# Rezoning Transportation Analysis

Petition Number: 2024-018

Date	Description
03-27-24	First Review (KC)
04-24-24	Second Review (KC)

### 1. ~~Curblines:~~

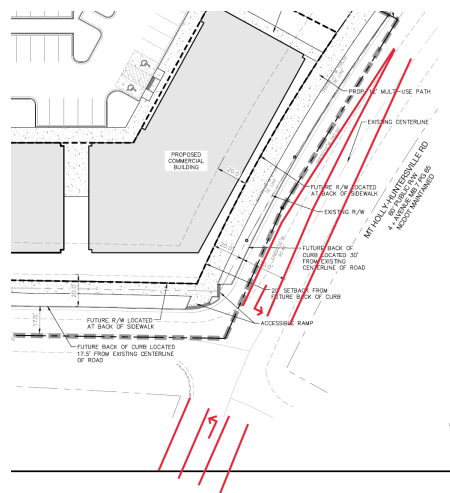
a. ~~**Mt Holly Huntersville Rd:** The future location of curb and gutter is 30' from centerline.~~

~~4+ Avenue, Shared Use Path per the Charlotte Streets Map~~

b. ~~**Harwood Lane:** The future location of curb and gutter is 17.5' from centerline.~~

~~CLDSM standard Local Collector Street U-07B~~

~~Label and dimension the curb and gutter from the centerline for each road on the site plan. Show proposed striping layout for Mt Holly Huntersville Road and commit to restriping for left turn lane on Mt Holly Huntersville Road at Harwood Lane.~~
